Intersection ID: 42944	Main Street: TURNING_WHEEL_DR	Cross Street: SONOMA_VALLEY_DR	Location:	SE
ADA ID: C978064FEAC9	Ramp Type: PerpDiag	Initial Pass/Fail: Fail	Overall Compliance: No	Severity Score: 10

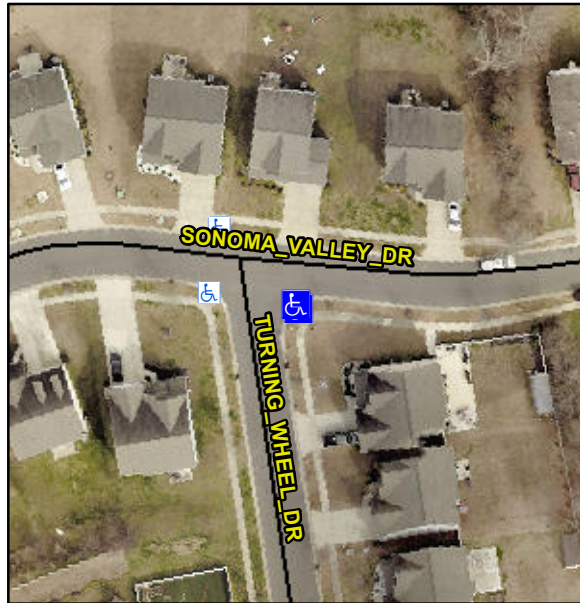
Not Found, R304.5.1, R304.5.3

Compliance	Description	Data	Compliance	Description	Data
N/A	Ramp Length (in)	70.5	Yes	Ramp Slope (%)	5.0
No	Ramp Width (in)	47.0	No	Ramp XSlope (%)	4.5
N/A	Flare Type LT	N/A	N/A	Flare Type RT	N/A
N/A	Flare Slope LT (%)	N/A	N/A	Flare Slope RT (%)	N/A
N/A	Flare Traversable LT?	N/A	N/A	Flare Traversable RT?	N/A
N/A	Landing Length (in)	N/A	N/A	DWS Provided?	N/A
N/A	Landing Width (in)	N/A	N/A	DWS Contrast?	N/A
N/A	Landing Slope (%)	N/A	N/A	DWS Length (in)	N/A
N/A	Landing X Slope (%)	N/A	N/A	DWS Full Width?	N/A
N/A	Landing Curb? (Y/N)	N/A	N/A	DWS Offset (in)	N/A
N/A	Shared Landing?	N/A			
N/A	Gutter Ponding?	N/A	N/A	Gutter Slope (%)	N/A
N/A	Gutter Lip Ht (in)	N/A	N/A	Gutter X Slope (%)	N/A
N/A	Painted X Walk1?	No	N/A	Painted X Walk2?	No
	X Walk 1 Direction	To N		X Walk 2 Direction	To W
N/A	X Walk 1 Width (in)	N/A	N/A	X Walk 2 Width (in)	N/A
	X Walk 1 Slope (%)	3.7		X Walk 2 Slope (%)	0.2
	X Walk 1 X Slope (%)	1.7		X Walk 2 X Slope (%)	0.5

Remove & Replace Curb Ramp With Two New Directional Ramps or Equivalent.
